REMARKS/ARGUMENTS:

Claims 9 and 20: PTO rejected claims 9 and 20 as being anticipated by Allison (4,065,225), stating that “Allison discloses a co-axial multi-rotor wind turbine having a counterweight 12 forward of a pivot point serving to at least partially counterbalance a downwind section of the driveshaft 32 and its attached rotors.”

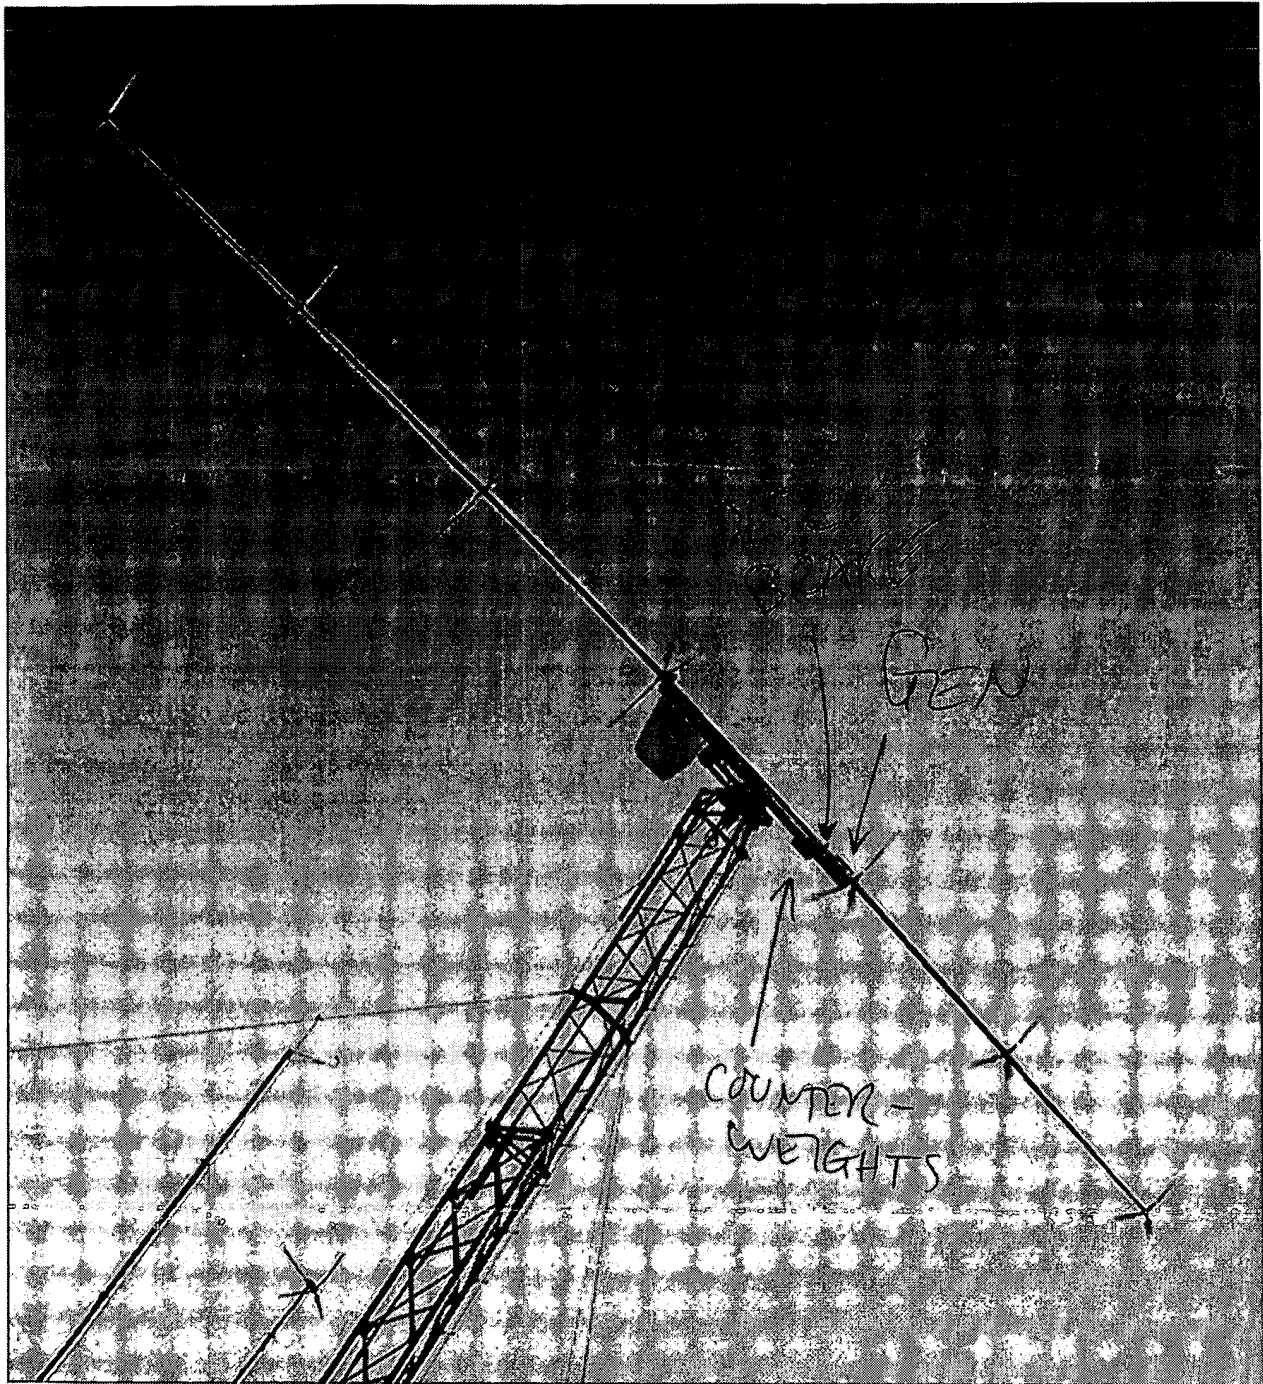
Left: Applicant's actual prototype, funded by the California Energy Commission, with brake, generator, dedicated counterweights, and massive parts of the support frame located upwind of a central pivot, counterbalancing the downwind section of the driveshaft and its attached rotors.
